EN 13445 "Unfired pressure vessels" Maintenance Help Desk (MHD) Question form

Request reference number (to be filled by MHD): (2014)-03-41				Date: 201X-xx-xx	
Please fulfil the following					
Part: EN 13445-3	Issue: 2014	Page 149	Subclause 10.6	National Standard Reference --	
Subject: Openings in flat heads					
Type of request:					
<input type="checkbox"/> Technical clarification		<input checked="" type="checkbox"/> Editorial correction			
<input type="checkbox"/> Technical comment		<input type="checkbox"/> Translation correction			
From :					
Company: Lloyd's Register EMEA.....			e-mail: andrea.magri@lr.org.....		
Name: Andrea Filippo Magri.....			phone: + 39 334 6628013		
Postal address: Via Cadorna 69, 20090 Vimodrone (MI) Italy					
<input type="checkbox"/> Manufacturer	<input type="checkbox"/> User	<input checked="" type="checkbox"/> Other (please specify): Notified Body

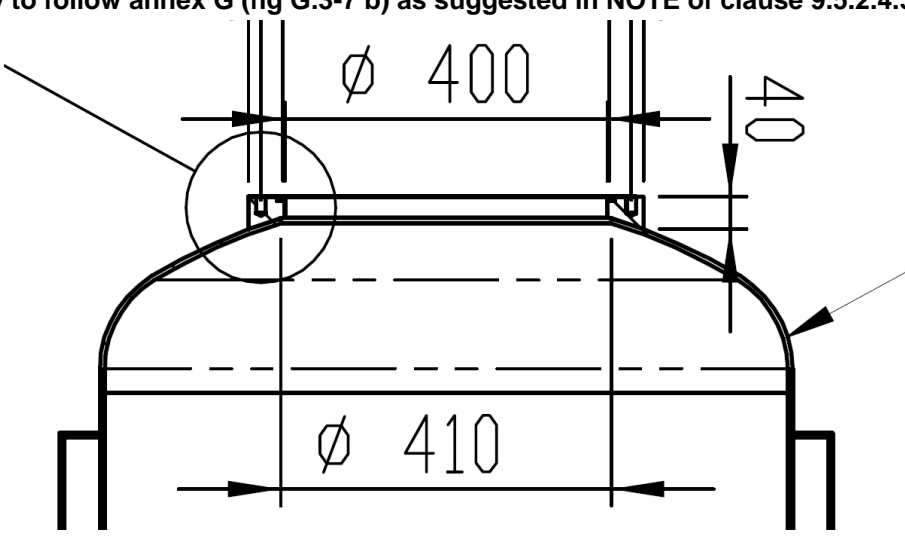
Question/comment:				
<p>Considering allowable stress if manufacturer use ASTM/ASME materials, for example SA-240 tp 304. Specifications are given for Rp0.2% room temperature. Only ASME II-D table Y-1 gives indications above 30°C.</p> <p>As per subclause 6 of EN13445-3 it is not possible to use Rp1.0 because data are not available so it must be necessary to use Rp0.2 (in lieu of Rp1.0) in formulas of subclause (see table 6-1).</p>				
<u>Proposed answer(s): *</u>				
<p>Yes, Rp0.2 in lieu of Rp1.0 must be used if ASME materials are used with EN13445-3. No possibility to change these values (See notes of footnotes of table Y-1, ASME II-D) unless special agreements with steel manufacturer are made and reported in material certificate.</p> <p>Since there are no formal data available in the Code it is not permitted to extrapolate data to give Rp1.0 prediction. This is an extension of footnote b) of EN13445-3 table 6-1</p> <p>See also "Comparison of ASME Specifications and European Standards" publication 16/12/2005</p>

Answer from the MHD (to be filled by MHD):				
<p>The proposed answer is incorrect. If ASTM/ASME materials are used then a Particular Material Appraisal is required – see EN 13445-2 sub-clause 4.3.3 and PED Annex I, clause 4.2(b) – and the properties of the material needed in order to evaluate the design stress shall be specified in the PMA. Clause 4.3 of Annex I of the PED requires that documentation prepared by the material manufacturer affirming compliance with a specification shall be obtained for all materials. In this case the specification would be taken as being the PMA. It is up to the vessel manufacturer to specify in the PMA the properties that are required in order to evaluate the design stresses in accordance with EN 13445-3 clause 6.</p>				
To be sent to EN 13445 Maintenance Help Desk secretariat:		EN 13445 MHD secretariat c/o UNM Standardization Office on behalf of AFNOR F 92038 Paris La Défense Cedex – France e-mail: en13445@unm.fr

Figure: flat end welded directly to the shell

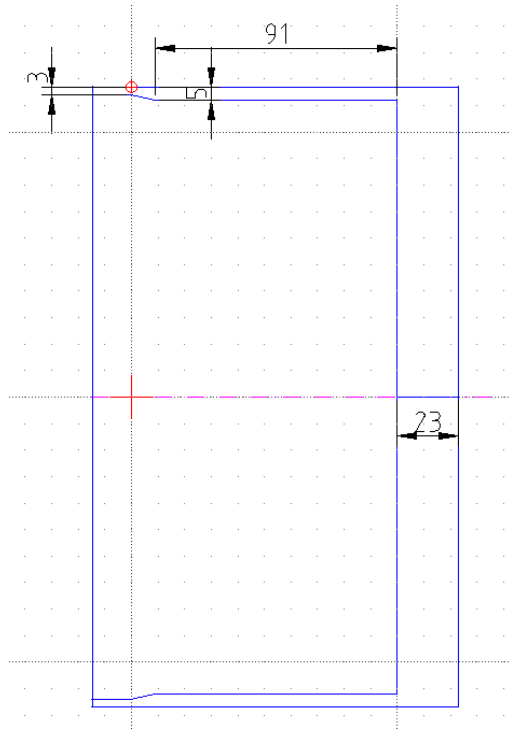
Question/comment: The iteration from 0 MPa to find the MAWP leads to a different result than iteration from for example 50 MPa to find the MAWP, in the example the MAWP is 4.29 MPa versus 7.91 MPa.				
This happens due to the note for C_2 on page 137. For the iteration from 0 MPa upwards, C_2 is valid and the second part of formula 10.4-10 is valid. For the iteration from 50 MPa downwards C_2 becomes negative and the second term of 10.4-10 is not required, and the factor C_1 is smaller than C_2				
Attached is the example flat plate, with dimensions, material and design conditions.				
Proposed answer(s): *				
Change note to: When the values of e_s/D_i and P/f_{min} result in a value of the coefficient C_2 less than 0.3, the internal pressure P is too high.

- Dimensions as above with 0.5 mm corrosion
- Material SA-105 flat end, SA-106 gr. B cylinder/pipe
- Design condition: pressure 1.36 MPa, temperature 250 Celsius

Pressures:	1.36 MPa	4.29 MPa ¹⁾	7.91 MPa ¹⁾	50 MPa
C1	0.365	0.399	0.408	0.436
C2	0.361	0.554	-0.573	-0.126
e _a analysis thickn.	22.5 mm	22.5 mm	22.5 mm	22.5 mm
e (10.4-10)	8.25 mm	22.48 mm	22.1 mm ²⁾	59.29 mm ²⁾

Answer from the MHD (to be filled by MHD):				
there is no MAWP in this standard When C_2 is negative the calculation shows that the thickness is not acceptable.				
To be sent to EN 13445 Maintenance Help Desk secretariat:		EN 13445 MHD secretariat c/o UNM Standardization Office on behalf of AFNOR F 92038 Paris La Défense Cedex – France e-mail: en13445@unm.fr

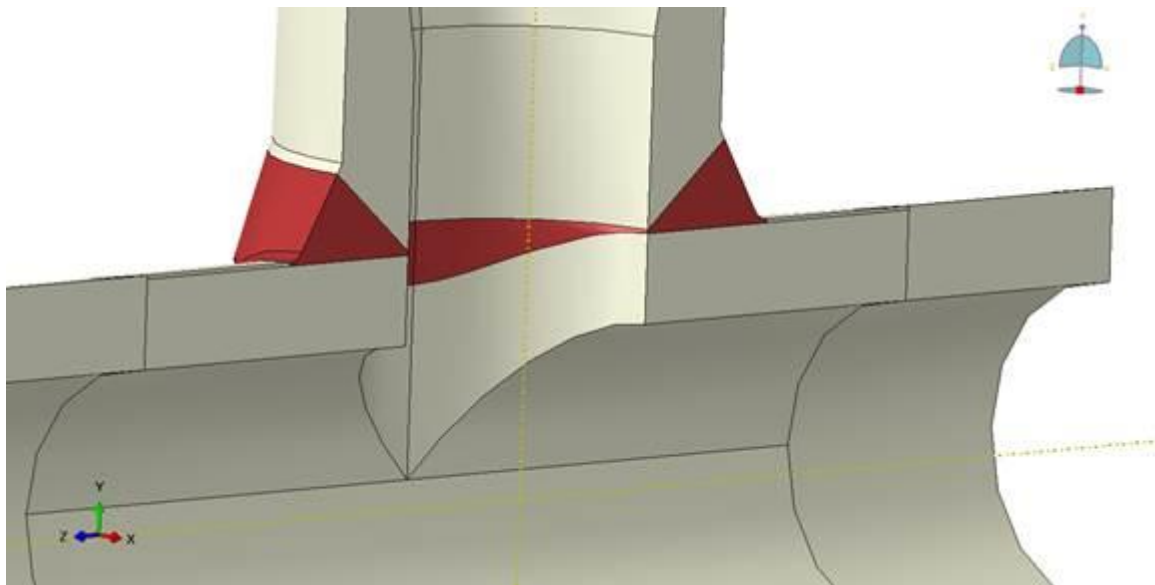
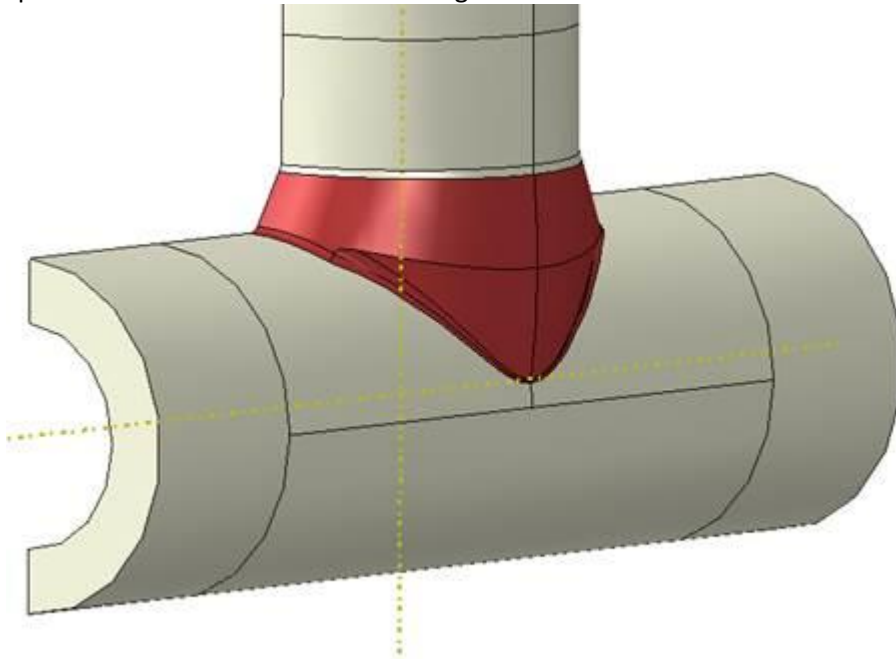
Question/comment:					
Re: EN 13445-3 ; Clause 9.5.2.3.1 Reinforcing pads					
This clause state that for the calculation of Af_p equation (9.5-20) shall be used.					
Equation (9.5-20) reads: $e_p = \min (e_{a,p} ; e_{c,s})$. This means that the reinforcing pad thickness up to no greater value than the shell thickness may be used in the calculation of Af_p .					
Suggest to limit the pad thickness to 1.5 instead of 1.0 x shell thickness when calculating Af_p .					
This is in line with practices successfully used in other recognised codes and standards.					
Proposed answer(s): *					
Reinforcing pads have a nominal thickness no greater than 1.5 times the nominal thickness of the main body.

Answer from the MHD (to be filled by MHD):					
The proposed answer is correct					
To be sent to EN 13445 Maintenance Help Desk secretariat:			EN 13445 MHD secretariat c/o UNM Standardization Office on behalf of AFNOR F 92038 Paris La Défense Cedex – France e-mail: en13445@unm.fr

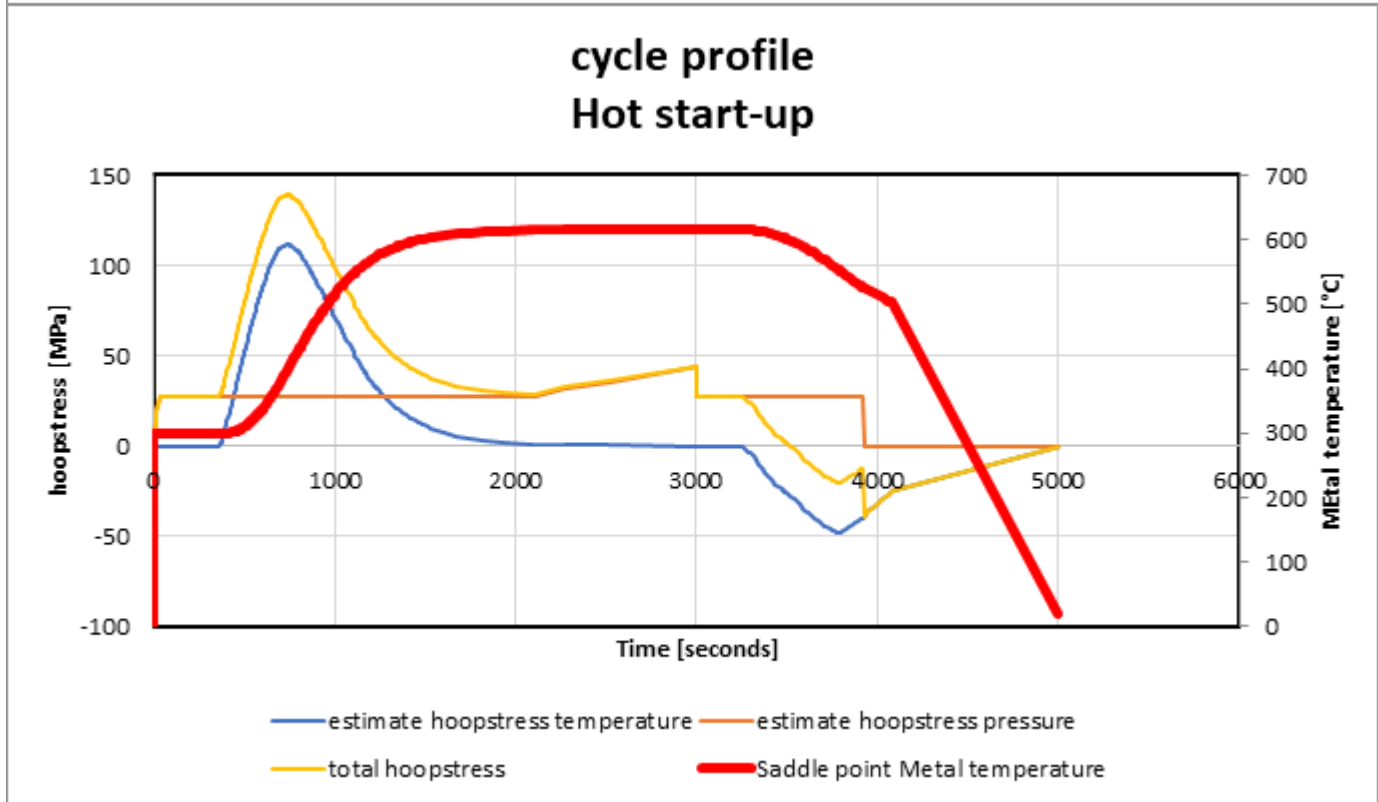
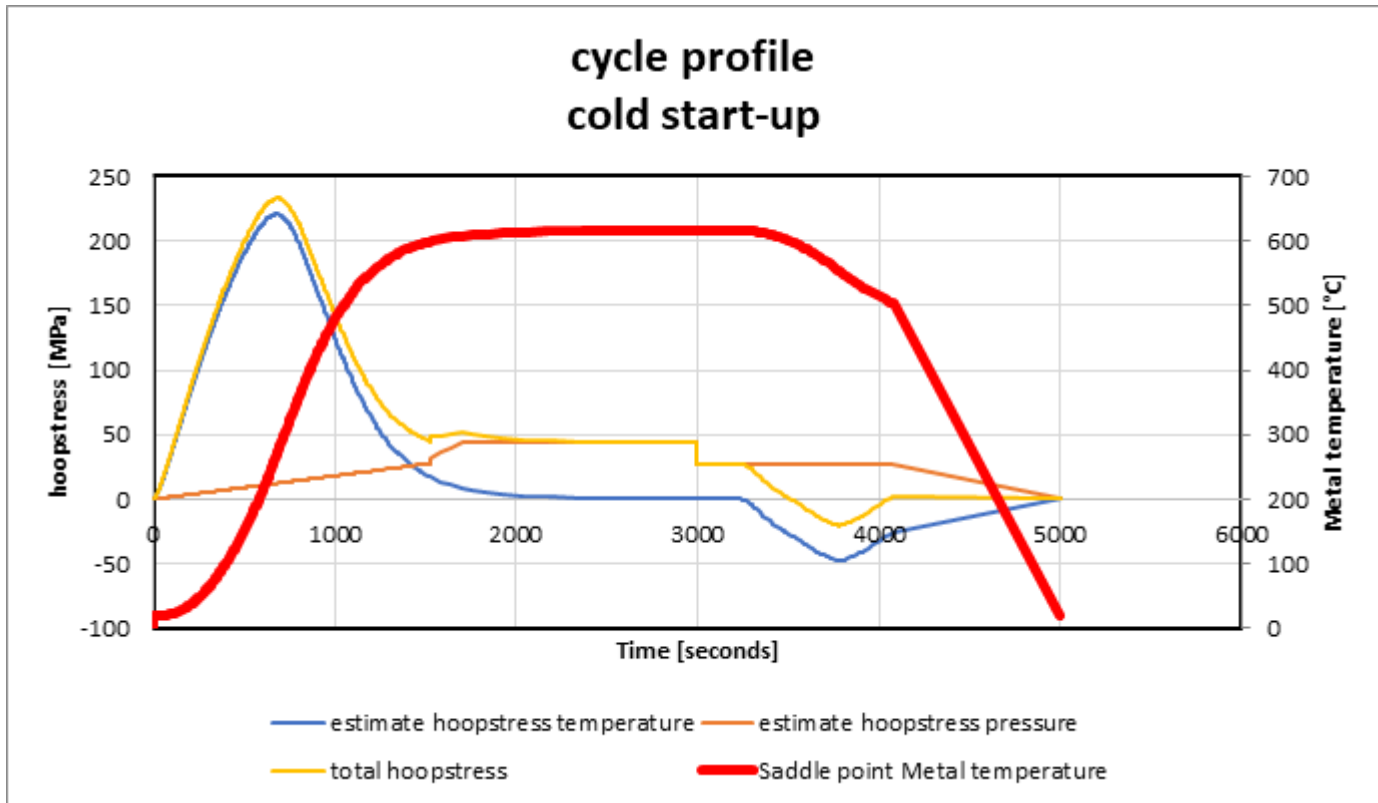
The component under consideration is a 1:1 T-branch with an outer diameter of 273.11 mm (DN250) and a wall thickness of 50 mm (both header and branch). Just for visualisation I have added a picture of a FE-model of this specific T-branch. The brown colouring is the weld metal. Base material is P91.

The component endures both a cold start and a hot start. The cold start endures a higher stress range, but the start temperature is low (20°C). For a hot start, the stress range is smaller, but the start temperature is higher.

Based on the assumption that T_{min} is that start temperature of the process in equation " $T^*=0.25T_{min}+0.75T_{max}$ ", this start temperature will have a large influence on the fatigue behaviour.

My question to you or the EN-pressure vessel committee is the following: How must we interpret the "Tmax" and "Tmin" in equation 18.10-14 of EN13445-3?

Based on table 18-4 the weld between a branch and header/vessel should be classified within picture 3.2. Weld toe is not dressed but we have a full penetration weld. FAT Class 71 could be used

However, this weld class picture is for a nozzle/header detail, where the nozzle diameter is smaller than the header diameter. In the saddle point of this T-branch the weld looks more like this:

Our question: which FAT class is the appropriate one?

Answer: If there is no stress cause by temperature make a calculation for the number of cycle of cold start and a calculation for a number of cycle of hot start and make a calculation for cumulative damage factor.

Answer: 3.2 is the appropriate one
